UNITED STATES
DEPARTMENT OF THE INTERIOR
BUREAU OF LAND MANAGEMENT

FORM APPROVED
OMB NO. 1004-0137
Expires: January 31, 2018**SUNDRY NOTICES AND REPORTS ON WELLS**
Do not use this form for proposals to drill or to re-enter an abandoned well. Use form 3160-3 (APD) for such proposals.5. Lease Serial No.
NMNM111406

8. Well Name and No.
DOUBLE TROUBLE FEDERAL 19. API Well No.
30-015-33931-00-S110. Field and Pool or Exploratory Area
CEMETERY-WOLFCAMP
UNDESIGNATED11. County or Parish, State
EDDY COUNTY, NM**SUBMIT IN TRIPLICATE - Other instructions on page 2**

Permanent Abandonment of Federal Wells
Conditions of Approval

Double Trouble SWD No. 1

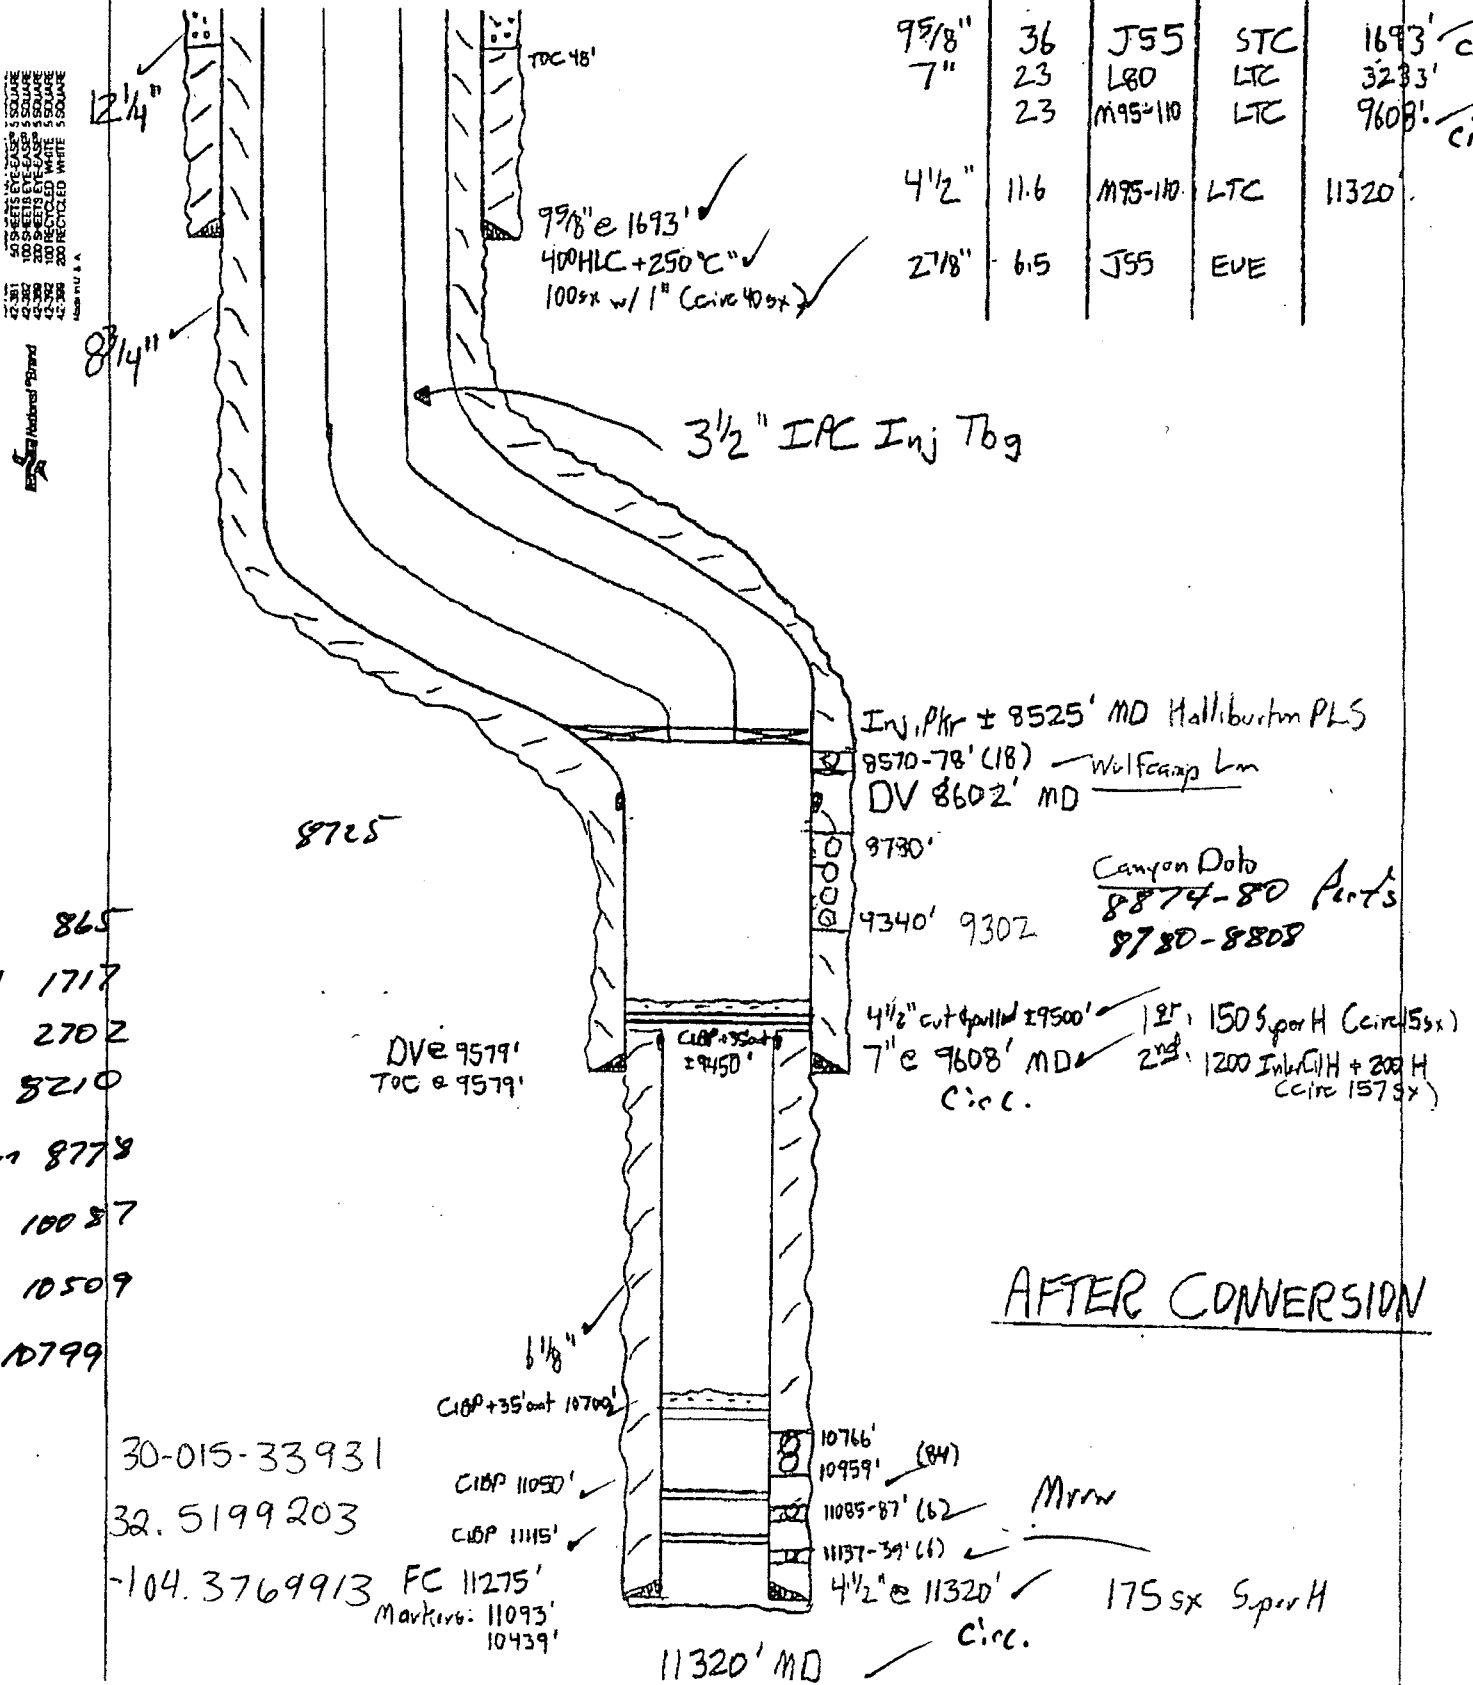
1. Spot 25 sx cmt @ 8520' ~~8420'~~ WOC & Tag *8160 (Top Wolfcamp & Parts) WOC Tag*
2. Spot 25 sx cmt @ 5100-~~5000'~~ *4950 (50 min) (Spacer)*
3. Spot 25 sx cmt @ 2800-2670'
4. Spot 25 sx cmt @ 1743-1623' WOC & Tag (9 5/8" Shoe) *Add Plug, 915-815 (SA)*
5. Spot 25 sx cmt @ 100'-Surface.
6. Cut off well head, verify cement to surface, weld on Dry Hole Marker. 1.

**** BLM REVISED ** BLM REVISED ** BLM REVISED ** BLM REVISED ** BLM REVISED *****78*
